RESPONSE TO REVIEWER COMMENTS:

Authors' General comment: Thank you again for the Reviewer's constructive comments concerning our manuscript entitled "Sensitivity analysis of a built environment exposed to debris flow impacts with 3-D numerical simulations" (ID: nhess-2022-173). We have the greatest respect for Reviewer's professional opinions on the debris flow hazard. Reviewer's comments are all valuable and very helpful for revising manuscript and improve our research. We have studied comments carefully and have made corrections which we hope meet with approval. Revised portions are marked in red in the paper and response letter, and the manuscript is re-submitted in clean format to the Journal. Please also find below my response to Reviewer's comments.

Figure 1. The geometric dimensions of the experimental dam-break model

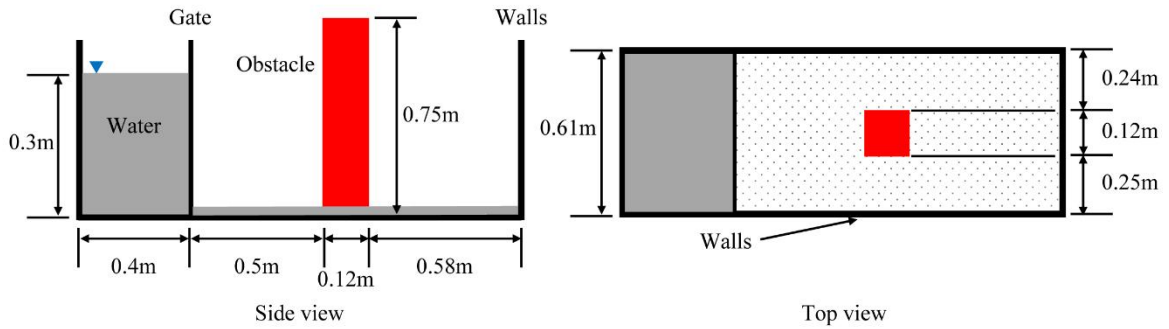
1. The main one concern the validation. In the laboratory experiment used for the validation, a well-mixed stony granular debris flow is reproduced. One of the main characteristics of this debris flow is that the energy dissipation is due to the collision between the particles and not by the viscosity of the fluid (e.g. Iverson 1997, Takahashi 2007, Armanini 2013). However, in the authors' response to my comment #1, it is highlighted that "From the characteristics of RNG k- ϵ model [that is used in all the manuscript], the type of debris flow involved in this study was determined as mudflow or viscous debris flow, in which a singlephase non-Newtonian fluid was assumed and solid particles were treated as suspension and mixed with the fluid phase well". This statement is completely in contrast with the used laboratory experiment used and consequently, all the section devoted to the validation of the model is meaningless since the author used a model that could not represent correctly the physical processes involved.

AUTHORS RESPONSE: We greatly appreciate for Reviewer's good comments! As Reviewer suggested, we have selected another classic dam-break experiment for the validation of fluid-structure interaction (Gomez-Gesteira and Dalrymple, 2004; Liu et al., 2021). The new statements about the model validation were added in [Line 128-157](#) of the revised manuscript.

The interaction between a dam-break and the structure has become a classic benchmark for the validation of fluid-structure interaction (Liu et al., 2021). The accuracy of the model will be validated by means of the experimental setup previously used in Gomez-Gesteira and Dalrymple (2004). This experiment has been referred as a "bore in a box", where it was a dam-break and structure-impact problem confined within a rectangular box. The geometric dimensions of the experimental model are shown in Fig. 1. The rectangular tank is 1.60 m long, 0.61 m wide and 0.75 m high. The volume of water initially contained behind a thin gate at one end of the box is 0.4 m long, 0.61 m wide and 0.3 m high. An initial layer of water (approximately 1 cm deep) existed on the bottom of the tank. The obstacle, which is 0.12 m \times 0.12 m \times 0.75 m in size, is placed 0.5 m downstream of the gate and 0.24 m from the nearest sidewall of the tank. The time history of the impact force on the structure was measured with a load cell.

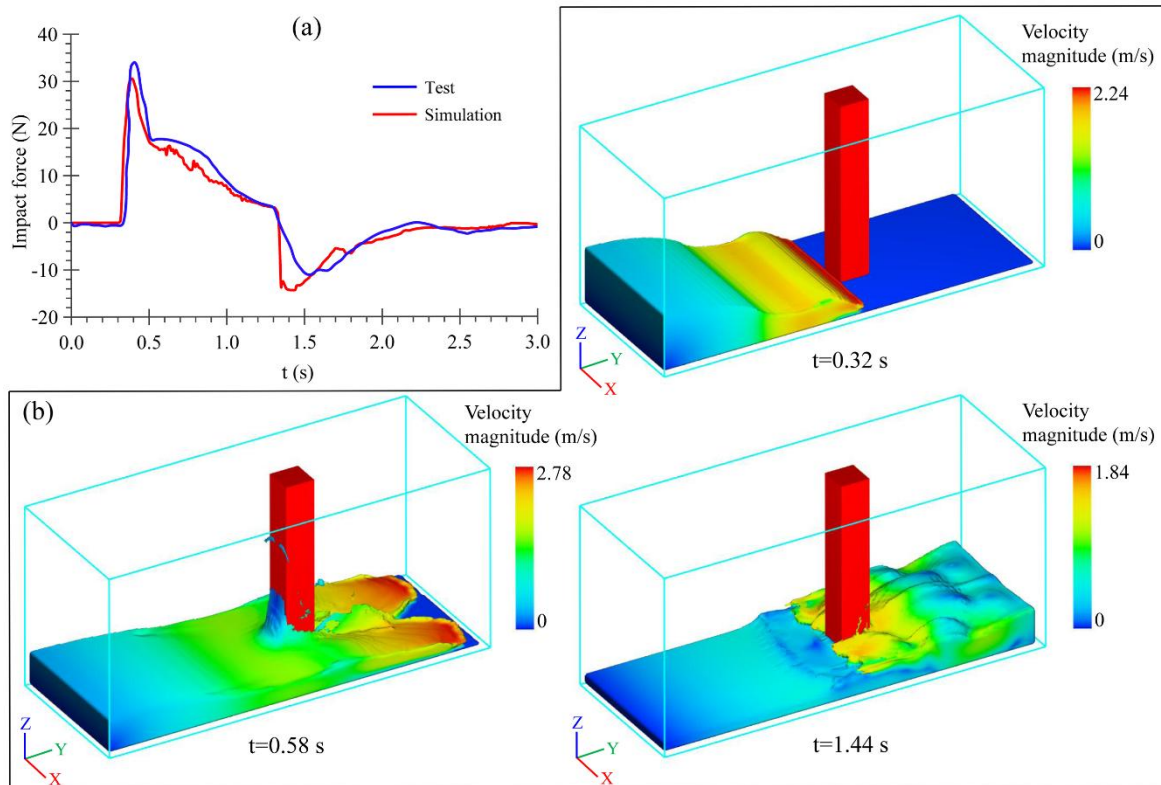
2. Another point of the validation part regards why the authors do not show the time history of the impact force. Since one of the characteristics of a debris flow impact process is its dynamic changes in time as the experiments of Song et al. 2021 show (the time history is quite complex and is not only represented by a single value!), the “simple” peak value is not sufficient for validating the model used. For this reason, I think that the authors' response “It is demonstrated that the RNG and GMO coupled model in FLOW-3D are able to describe the peak impact force and fluid surface effectively” is not fully trustable.

Fig. 2a shows the agreement of numerical forces obtained by means of the RNG and GMO coupled model with experimental data, particularly the positions of both peaks, which correspond to the wave hitting the front and the back of the structure and were reproduced perfectly by the numerical model. Fig. 2b shows the evolution of the wave generated by the dam-break and the initial layer of water on the bottom. At $t = 0.32 \text{ s}$, the wave is colliding with the front of the obstacle. At $t = 0.58 \text{ s}$, the wave is wrapping around the structure, colliding together and continues moving toward the tank wall. At $t = 1.44 \text{ s}$, the reflected wave is hitting the back of the obstacle.

AUTHORS RESPONSE: Thanks for Reviewer’s good suggestion! As responded in the comment #1, a new model validation has been executed, and the time history of impact force was determined to be compared, as shown in Fig. 2a.
